Poppy Reserve/ Mojave Desert Interpretive Association
(PR/MDIA)

DATE: February 19, 2015

RE: DRECP NEPA/CEQA (Sent via email and U.S. mail)

**DRECP PREFERRED ALTERNATIVE POTENTIALLY DEVASTATING
FOR THE ANTELOPE VALLEY
AND CALIFORNIA DESERT STATE PARKS**

Audubon Important Bird Areas DRECP Figure III.7-15

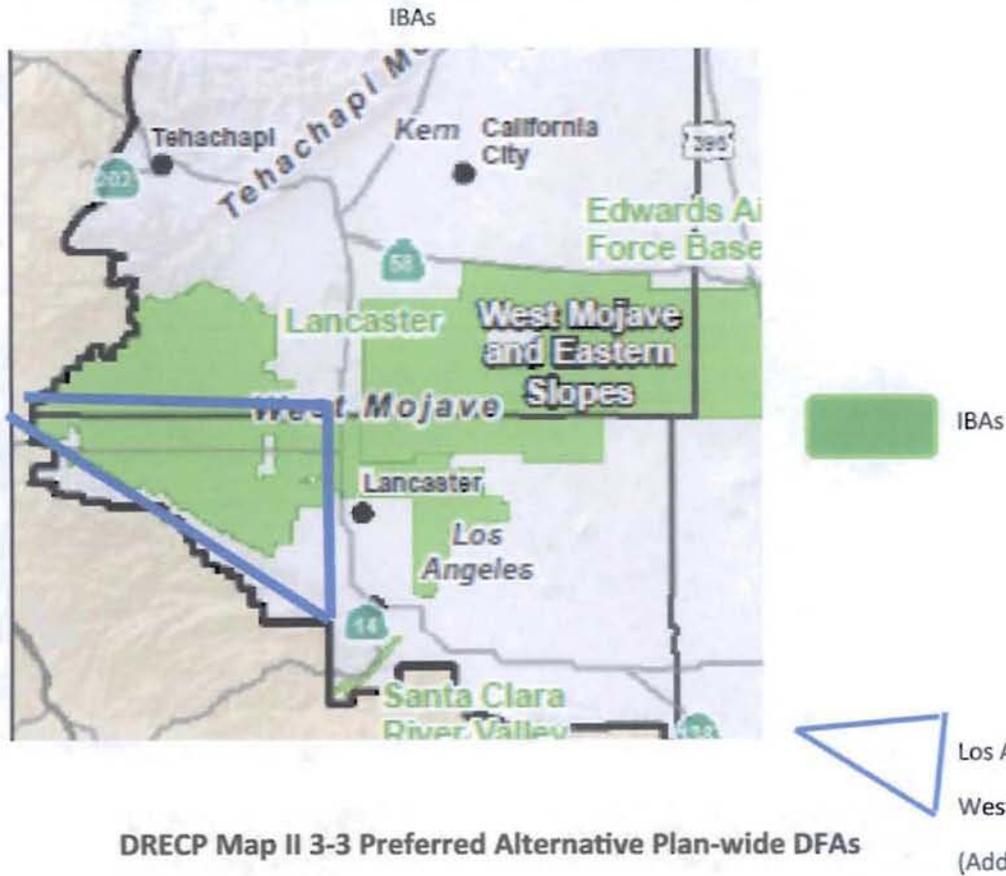
Given that information, it is again unacceptable that in regard to the West Antelope Valley, the Antelope Valley California Poppy Reserve, the largest area providing protection for bird species, has been surrounded with DFAs instead of Conservation Areas. **Instead the IBA in the western Antelope Valley has been blanket-ed with areas designated as DFAs as shown on the maps on the following page.** Again, labels for state parks are missing from these maps. (Blue lines added for clarification.)

- Audubon Important Bird Areas should not be blanketed with DFAs without regard to essential habitat. DFAs should not threaten biological and recreational resources of LLPAs. We recommend the following three changes to DFAs:

Red Rock Canyon State Park

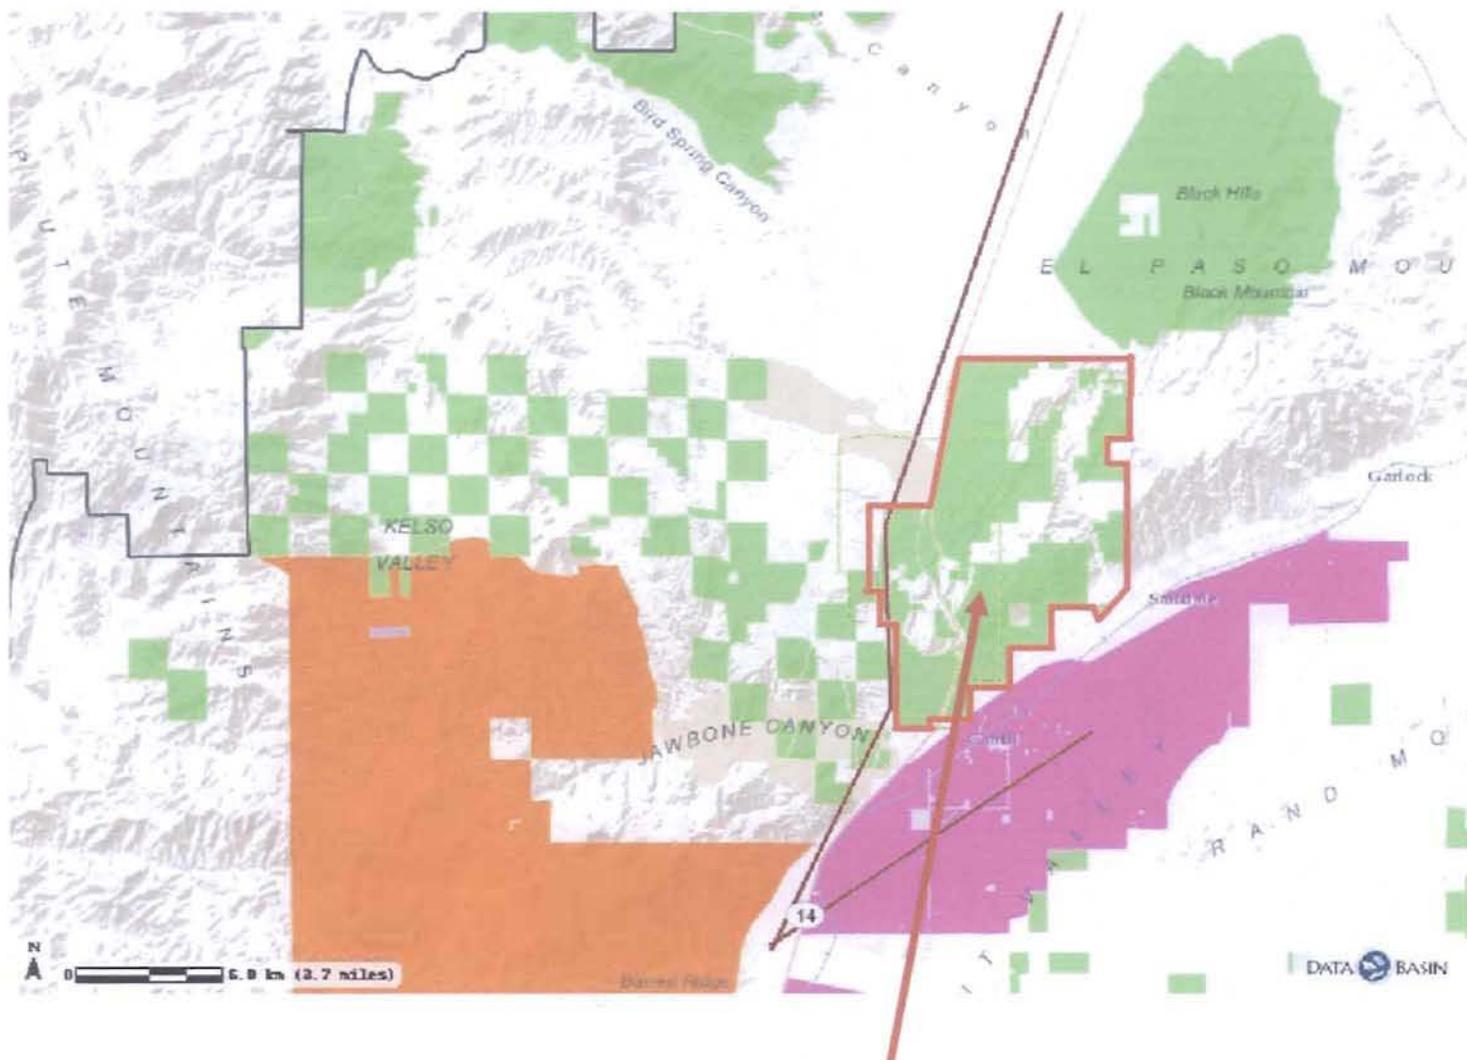
We now see these iconic views and threatened species imperiled by a large DFA proposed in the Preferred Alternative for the southern border of the Red Rock Canyon. Again, it would be difficult for a member of the public to become aware of this threat as this park is not properly labeled on DRECP maps. The approximate location of the park is indicated by the red lines added for purposes of clarification to the Preferred Alternative DFA map shown on the next page. It should be emphasized that red lines added to show the location of Red Rock Canyon State Park are not part of the original DRECP map.

The pattern we see throughout the DRECP of the lack of labeling for California Desert State Parks is again repeated for Red Rock. It is mystifying that important landmarks such as Jawbone Canyon, Kelso Valley and the Black Hills all appear on the DRECP map shown on the following page **but Red Rock Canyon State Park does not!** It is impossible for the public to make "substantive" comments concerning the Preferred Alternative without proper and complete maps; **the lack of such maps is an inexcusable omission.**

The location of the Red Rock Canyon State Park is indicated by the red lines added for purposes of clarification (and to the best of our ability) to the Preferred Alternative DFA map shown above—these lines are not part of the original DRECP map.

A larger scale version of this map does label Red Rock, however once a user zooms in on the area, that name disappears although others remain.

Why are many landmarks such as Kelso Valley, Jawbone Canyon and Black Mountain included on this map but nothing included to indicate the location of Red Rock Canyon State Park? How can the public make informed comments without this information?

3. Eliminate DFA south and southeast of Red Rock Canyon State Park.
- Conservation Planning Areas in the Western Antelope Valley must provide for protection of tricolored blackbird habitat. Conservation Planning Areas in IBAs should be adjacent to existing LLPAs and protect biological and recreational resources and connectivity for these protected areas. To accomplish this, we suggest the following two additional conservation areas:

Antelope Valley Indian Museum

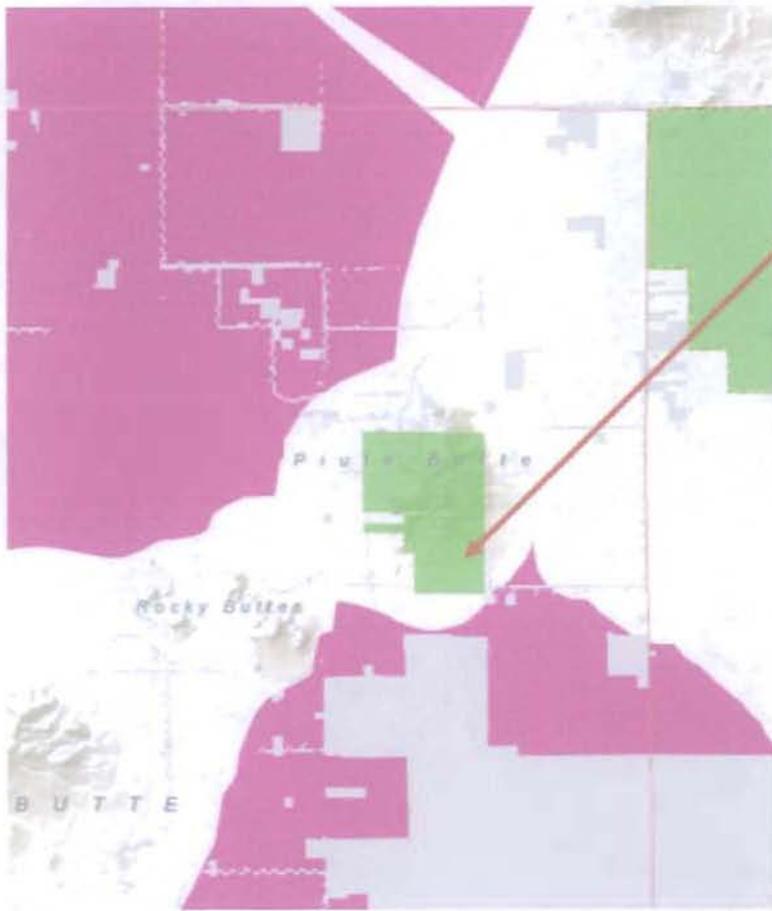
Following the pattern of excluding labeling for California State Parks from DRECP maps, Piute Butte is shown on the Preferred Alternative map, but the Antelope Valley Indian Museum, represented by the green area with Piute Butte on the north, is not labeled. DFAs shown in pink south of the park are in the primary viewshed of the park looking south across the desert to the San Gabriel Mountains from the park's nature trail, picnic area and the front patio of the museum building.

1. Eliminate DFAs in the Western Antelope Valley from all areas west of 110th Street West and south of Avenue D
 2. Eliminate DFA south of the Antelope Valley Indian Museum.
